51 MW WIND POWER PROJECT AT CHITRADURGA

Project Title	51 MW Wind Power Project at Chitradurga
Version	1.1
Report ID	VKU.VER.71.22_VCS_706

Report Title	51 MW Wind Power Project at Chitradurga
Client	NSL Renewable Power Pty Ltd
Pages	84
Date of Issue	14-October-2023
Prepared By	VKU Certification Pvt. Ltd.
Contact	Regd. Off: Flat No. 306, Sky Star, N-1, New Rani Bagh Khandwa Road, Indore, Madhya Pradesh - 452020 URL: http://vkucertification.com e-mail: info@vkucertification.com
Approved By	Dr.Vikas Kumar Aharwal (Founder and Director) vikas.aharwal@vkucertification.com
Work Carried Out By	Barun Kumar - Team Leader cum Technical Expert T.A 1.2 (Local Expert - Country: India) Niharika Kaushik - Validator/Verifier Anil Dhankar – Project Trainee Sanjay Kumar- Technical Reviewer cum Technical Expert T.A 1.2

Figure No 02: Project Single Line Diagram

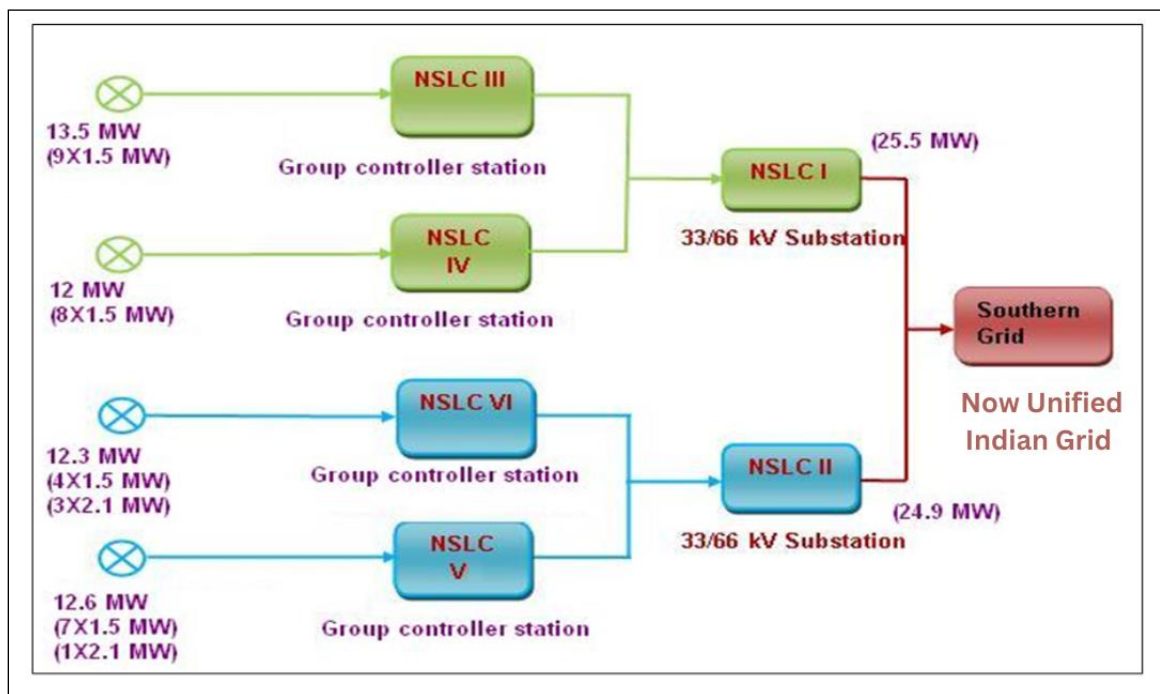
8. In Section 5.4 of MR: The assessment team has found that a table is missing in this section as per Section 5.4 in VCS MR template version 4. a) PP need to provide proper justification of the decreased ERs achieved in the project activity.				
1 st Response from PP		Date	05-October-2023

1. In Section 3.1 of MR: • SLD- Single Line Diagram is added in section 4.3 of MR. • The make model of WTGs is added in this section. • Date of commissioning is added in the section. • Section updated with Breakdown details 2. In section 3.2 of MR: No deviations were taken during the previous verification and validation processes. 3. In Section 4.1 of MR: Justification is added in Appendix 01 of MR also as per registered PD it is consistent. 4. In Section 4.3 of MR: • Link for the methodology used is added. • Voltage conversion is added. • The energy generation to conversion and then distribution to Grid is added. • The emergency procedures are added. 5. In Section 5.3 of MR: Link for the methodology used for this particular project activity is added. 6. In Section 5.4 of MR: Section has been updated 7. Justification of the lower achieved ERs as per estimated in the project activity is added

1 st Assessment by Audit Team	Status	Closed	Date	05-October-2023
1. In Section 3.1 of MR: • PP has incorporated the SLD- Single Line Diagram in section 4.3 of MR which is checked by the assessment team and found inline. (Closed) • PP has incorporated the make model of WTGs in this section and same has been verified by the assessment team and found correct. (Closed) • The assessment team confirmed that the Date of commissioning is incorporated in the section. (Closed) • The assessment team confirmed that Breakdown details are incorporated in the section. (Closed) 2. In section 3.2 of MR: PP has specified that No deviations were taken during the previous verification and validation processes. (Closed) 3. In Section 4.1 of MR: The assessment team confirmed that Justification is added in Appendix 01 of MR by the PP, the assessment team has checked and found it consistent with the registered PD. (Closed) 4. In Section 4.3 of MR:

Figure 03: Trends of PLF from May-2022 to December- 2022:

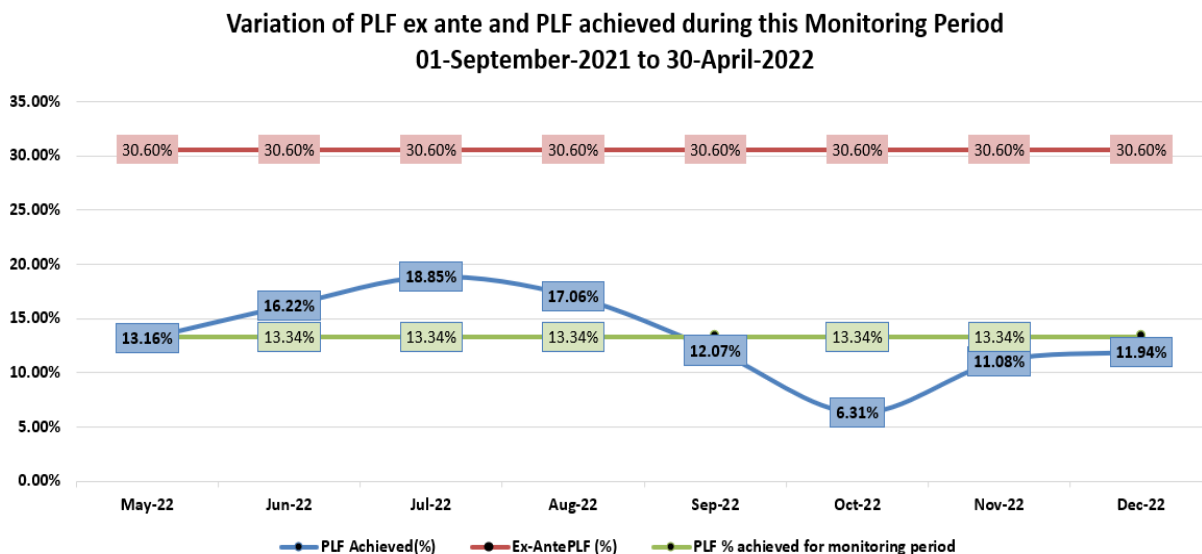
Based upon the Figure 03, it is clear that the monthly trend of PLF is lower than the estimated. This is reflected in lower emission reductions for the current monitoring period at 56.40%.
